EQUIPMENT/FURNISHINGS - ANNOUNCEMENT OF IPECO SB480-25-01 CARRIER AND BRAKE IMPROVEMENT FOR PASSENGER SEATS

MTL-25-03
Page 1 of 2

**CARRIER & BRAKE
IMPROVEMENT**

KINGAIR AIRCRAFT
SERVICE BULLETIN NUMBER
480-25-01
ISSUE 1

FIGURE 3

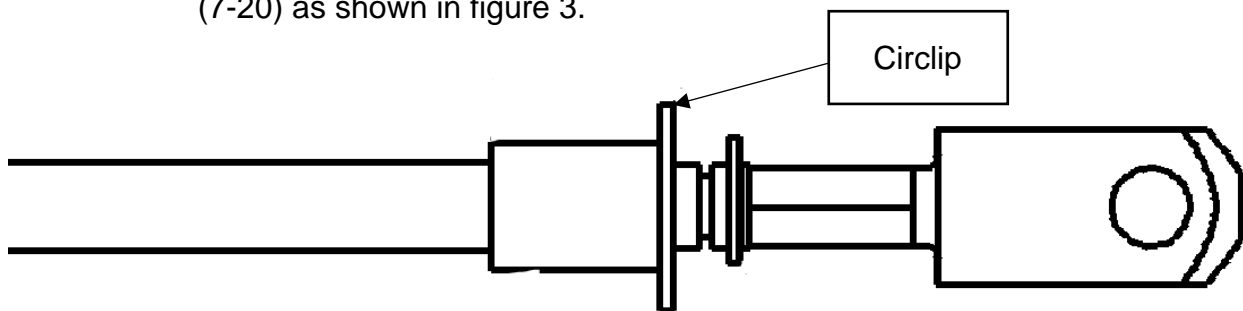
- h. Discard two lock nuts (3-75, 3-95), one grommet (7-245) and one spacer (7-250).
4. Remove the brake mechanism assembly-longitudinal (6-150, 6-155) from the outboard pan side member (6-245, 6-250) as follows:
 - a. Remove the slic pin (3-115) and the circlip from the cable - longitudinal lock (7-20) as shown in figure 3.

9. Install the brake mechanism assembly-longitudinal (1, 2) to the outboard pan side member (6-245, 6-250) as follows:
 - a. Attach the brake mechanism assembly-longitudinal (1, 2) to the outboard pan side member (6-245, 6-250) with four screws (6-160)
 - b. Connect the longitudinal lock cable (7-20) to the brake mechanism assembly-longitudinal (6-150, 6-155) with one slic pin (3-115) and one circlip (3).

FIGURE 4

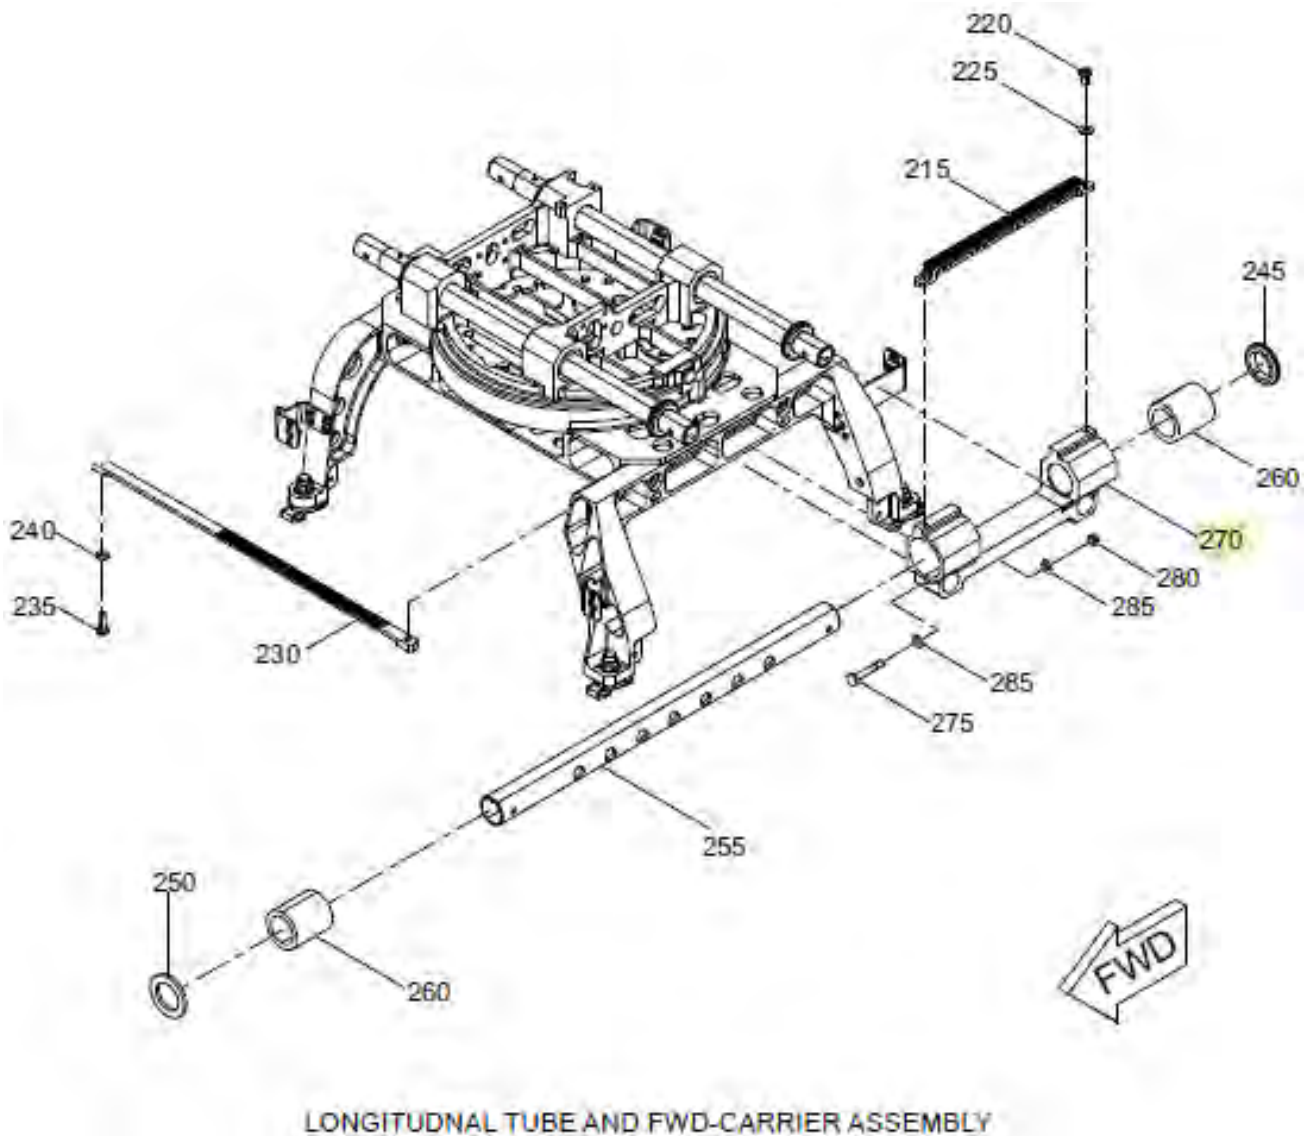
5. Remove the forward/ aft ward bearing carrier (7-265, 7-270) from the turntable & mechanism assembly base (7-1, 7-1A) as follows:
 - a. Remove one screw (7-235) and one washer (7-240) from the lateral serrated bar (7-230).

- b. Remove two bolts (7-275), two lock nuts (7-280) and four washers (7-285).
 - c. Remove the forward/ aft ward bearing carrier (7-265, 7-270) and two linear ball bushing bearings (7-260) as shown in figure 4.

- d. Discard two lock nuts (7-280), the forward/ aft ward bearing carrier (7-265, 7-270) and two linear ball bushing bearings (7-260).

10. Connect the upper seat assembly (3-5, 3-10) to the base turntable and mechanism assembly (3-105, 3-110) as follows:
 - a. Put two linear ball bearing bushes (4) into the forward/ aft bearing carrier (5, 6).

- b. Attach the forward/ aft bearing carrier (5, 6) to the lateral tube (7-330) with four washers (7-285), two lock nuts (7) and two bolts (7-275).
 - c. Rotate the upper seat assembly (3-5, 3-10) to the base turntable and mechanism assembly (3-105, 3-110).

- d. Put the longitudinal tube (7-255) into the forward/ aft bearing carrier (5, 6) through two linear ball bearing bushes (4).
 - e. Put two grommets (8) into the side of the longitudinal tube (7-255), position one grommet (8) to replace of the spacer (7-250).

- f. Attach the lateral serrated bar (7-230) to the two forward/ aft bearing carrier (5, 6) with one washer (7-240) and one screw (7-235).
 - g. Attach the longitudinal serrated bar (7-215) to the forward/ aft bearing carrier (5, 6) with two washers (7-225) and two screws (7-220).

FIGURE 5

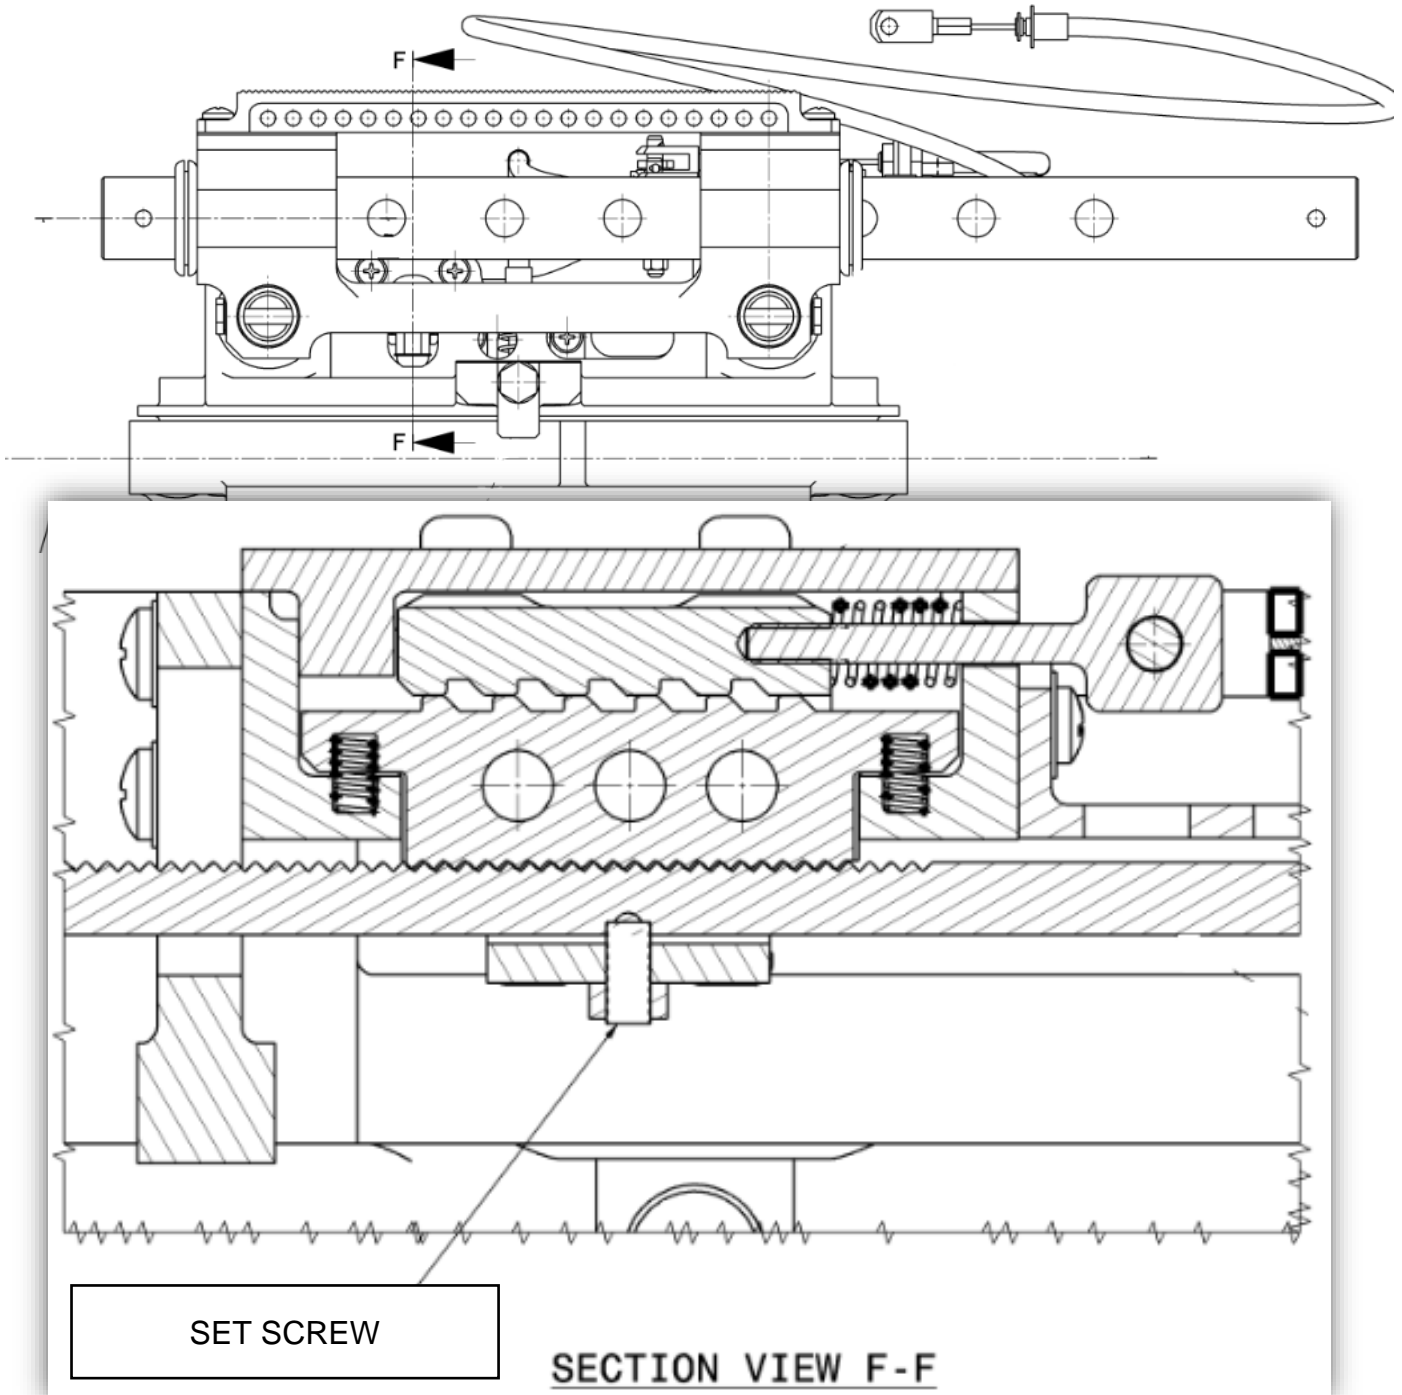
6. Remove the set screw from the turntable & mechanism assembly base (7-1, 7-1A) as follows:
 - a. Remove the set screw on the bottom of the lateral brake mechanism assembly (7-40) as shown in figure 5.
 - b. Discard the set screw.

11. Install set screw – ball end (10) to the turntable & mechanism assembly base (7-1, 7-1A) as follows:
 - a. Install set screw – ball end (10) using threadlock adhesive and one nut (11) to the bottom of the lateral brake mechanism assy (7-40) as shown in Figure 4.
 - b. Tighten set screw – ball end (10) enough to ensure full engagement of teeth between serrated – lateral bar (7-230) and the lateral brake mechanism assy (7-40).

FIGURE 6

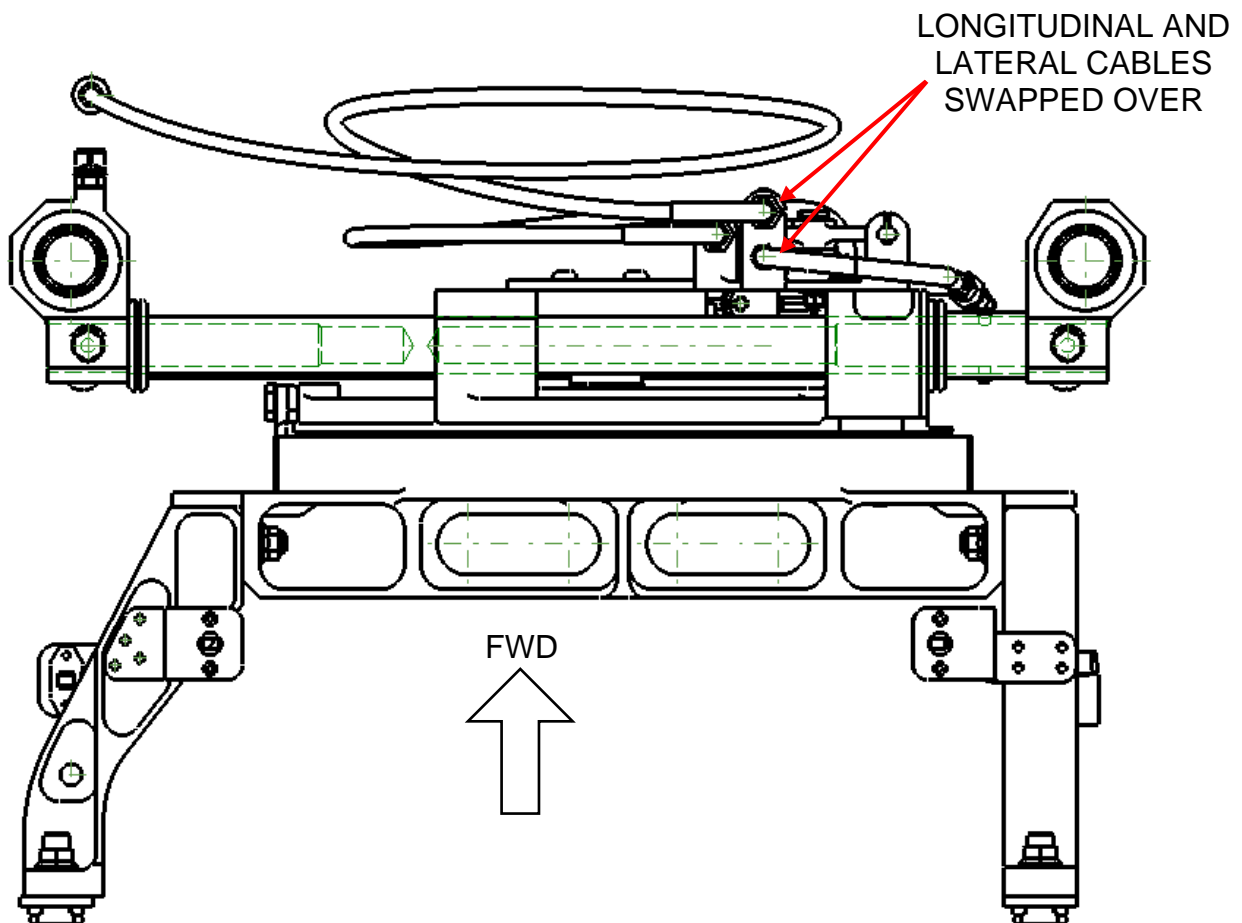
7. Change cable connections as follows:
 - a. Remove the slic pin (7-25) from the cable splitter assembly (7-120, 7-125).
 - b. Disconnect the lateral brake cable (7-10A) from the cable splitter assembly (7-120, 7-125).
 - c. Disconnect the longitudinal lock cable (7-20) from the cable splitter assembly (7-120, 7-125) and install the longitudinal lock cable (7-20) in the lateral brake cables (7-10A) position as shown in figure 6.
 - d. Install the lateral brake cable (7-10A) in the longitudinal lock cables (7-20) position as shown in figure 6.
 - e. Install slic pin (7-25) to the cable splitter assembly (7-120, 7-125).

FIGURE 7

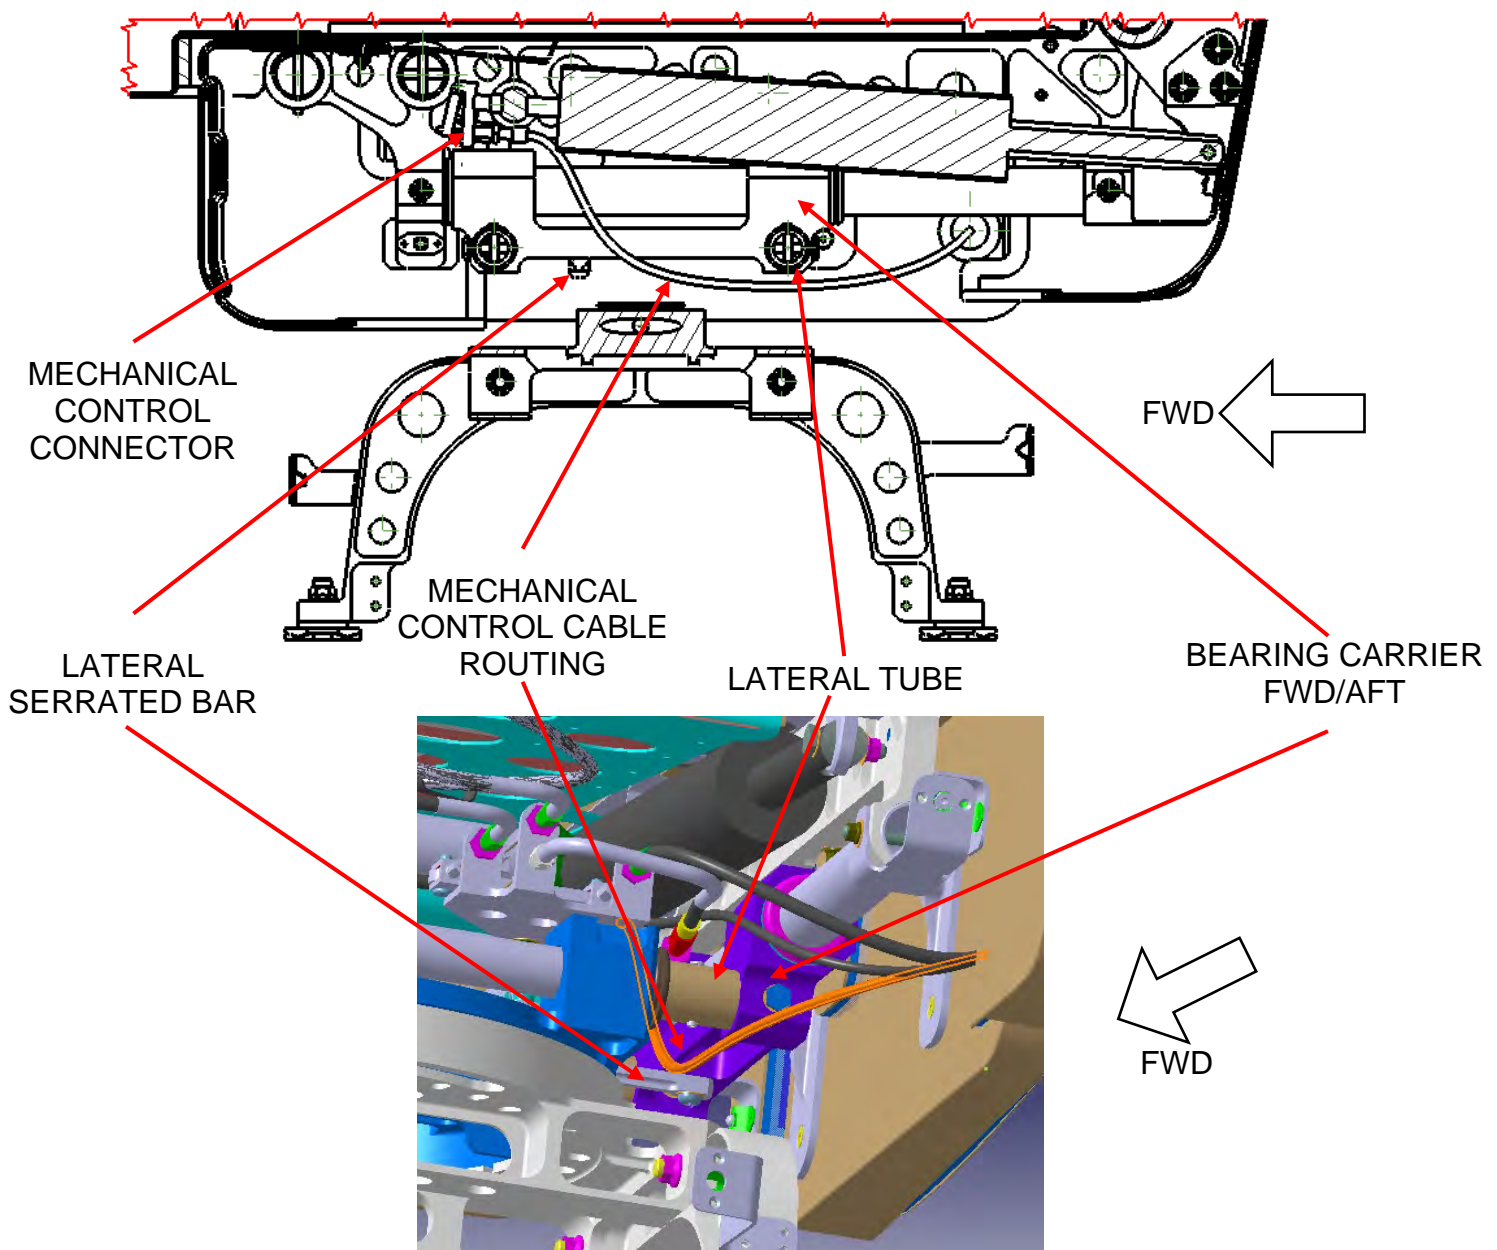
8. Change the recline unit cable routing as follows:
 - a. Disconnect the cable from the connector on the mechanical control (2-160).
 - b. Route the mechanical control cable (2-160) under the bearing carrier fwd/aft (7-290, 7-295), upward and between the rear lateral tube (7-330) and the lateral serrated bar (7-230) as shown in figure 7.
 - c. Connect the cable to the connector on the mechanical control (2-160).

FIGURE 8

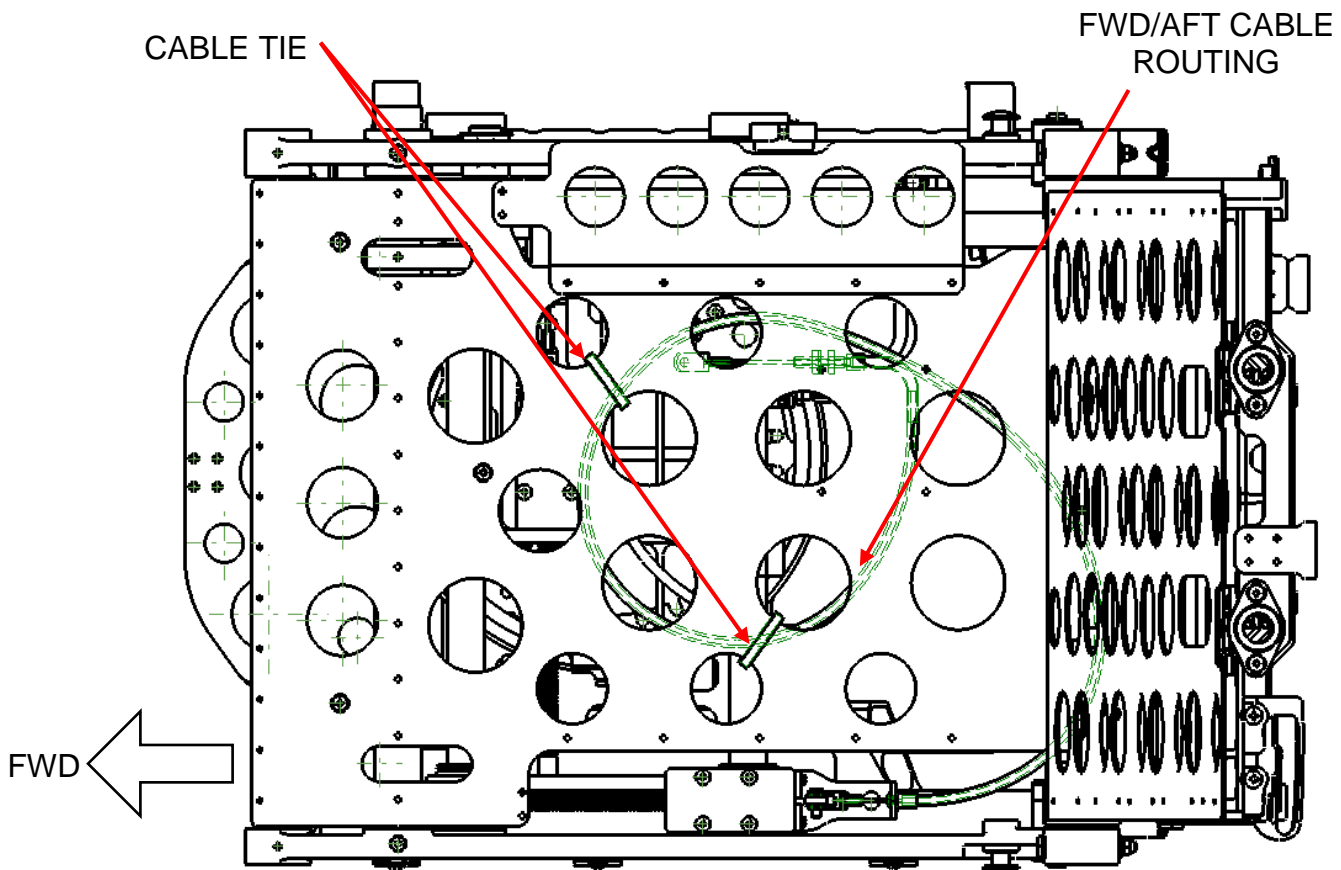
12. Attach two cable ties (12) to the pan structure assembly (4-25, 4-30) to secure the fwd/aft cable routing in positions as shown in figure 8.
